PRODUCT CHANGE NOTICE

1. TITLE IRHNA597160 Electrical Characteristics		2. DOCUMENT NUMBER FV5-C-20-0038
		3. DATE August 25, 2020
4. MANUFACTURER AND ADDRESS International Rectifier HiRel Products, Inc 205 Crawford Street Leominster, MA 01453		5. MANUFACTURER PART NUMBER See below for IR HiRel Part Numbers
		6. BASE PART NA
		7. NATIONAL STOCK NUMBER (NSN) NA
8. CAGE 69210	9. EFFECTIVE DATE August 25, 2020	10. GOVERNMENT NUMBER NA
11. POINT OF CONTACT Manufacturer's Representative or Account Specialist (978) 534-5776		12. DRAWING NUMBER NA
		13. SPECIFICATION NUMBER MIL-PRF-19500/713

IRHNA597160 [2N7550U2]

Change Figure 8 Maximum Safe Operating Area curve;

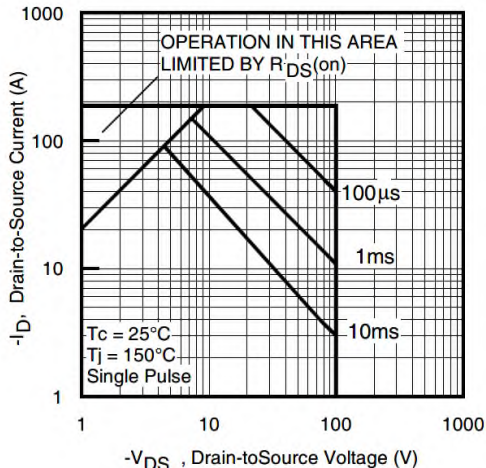
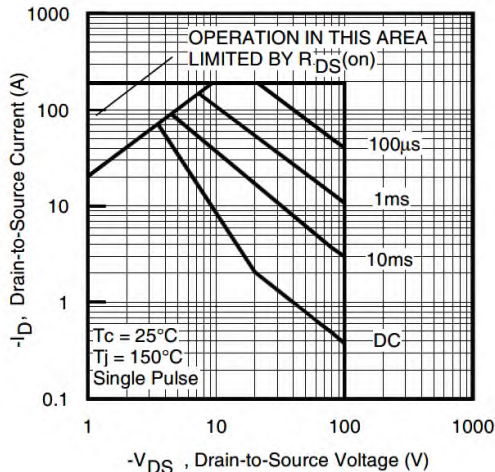
This GIDEP PCN is to announce specification change with the datasheet for the following International Rectifier HiRel Part Number. Note that this change is related to part specification update only, and not due to a die physical change.
